DATE: October 3, 2018

AGENDA ITEM # 2

TO: Design Review Commission
FROM: Zachary Dahl, Planning Services Manager
SUBJECT: 17-V-10 and 17-SC-36 – 899 Madonna Way

A1

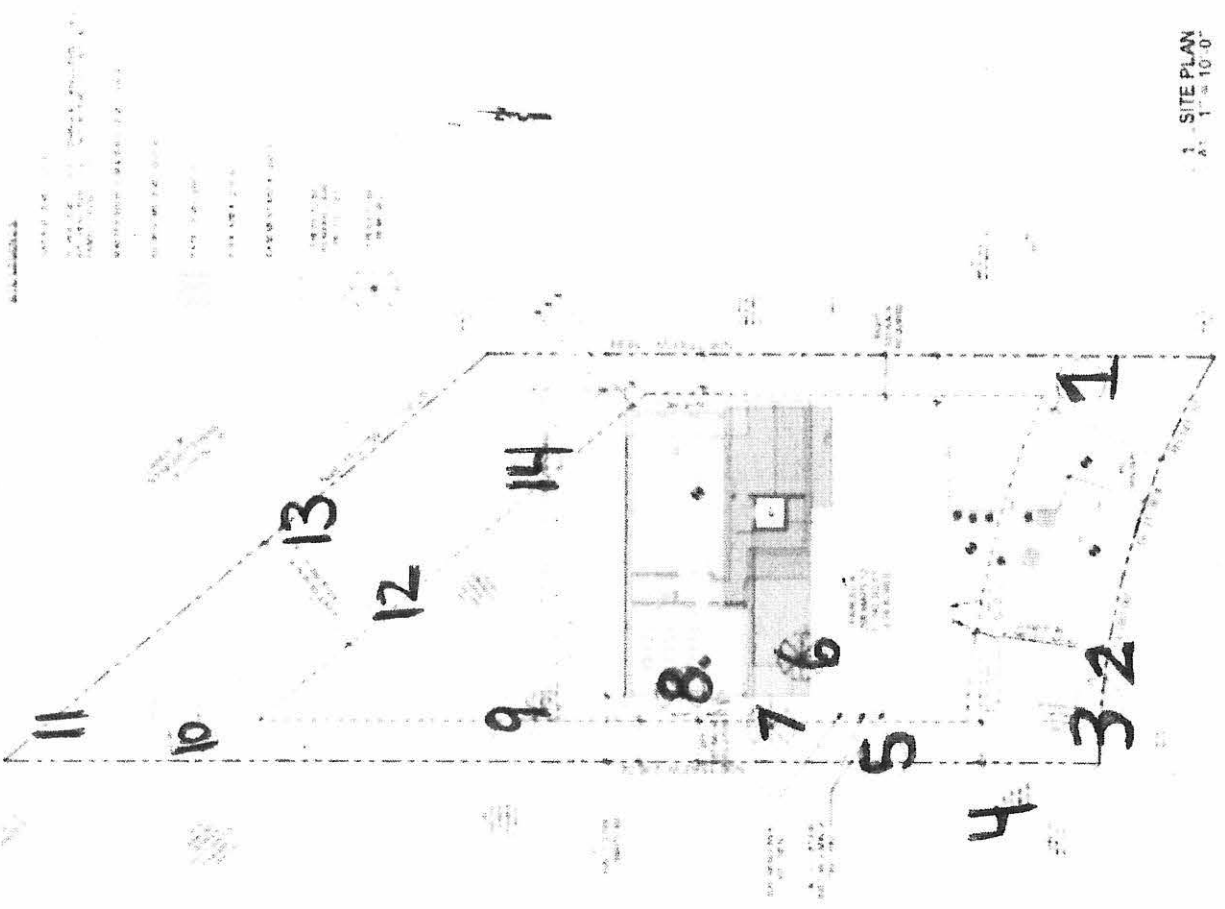
The average width of the subject parcel is 76 feet (see sheet A1), which is below the minimum width of 80 feet for a standard lot in the R1-10 District. For lots that are less than 80 feet in width, described as "narrow lots" in the Zoning Code, there is an allowance for side yard setbacks to be reduced from 10 feet to 10 percent of the average lot width, for any portion of a structure which is one story in height, with 7.5 feet added for any portion of a structure which is two stories in height. The table above provides the effective setbacks for this narrow lot.

cannot be supported by staff; however, it appears that these were not intentional and can easily be corrected. As defined by the Zoning Code, lot coverage is the percentage of net site area covered in structures in excess of six feet in height measured to the outside surfaces of exterior walls and the perimeter of any supports. As shown on Sheet A13, the structure's lot coverage goes beyond the outside wall of the bedrooms to the support poles below the balcony area. Staff estimates that the additional lot coverage results in the structure exceeding its limit by approximately 20 square feet.

- a. The building footprint shall be reduced to not exceed 3,823 square feet to comply with the property's lot coverage requirement.
- b. The proposed house size shall be reduced to not exceed 4,024 square feet to comply with the property's floor area ratio requirement.
- c. The project shall be revised to remove the basement proposed under the patio level.
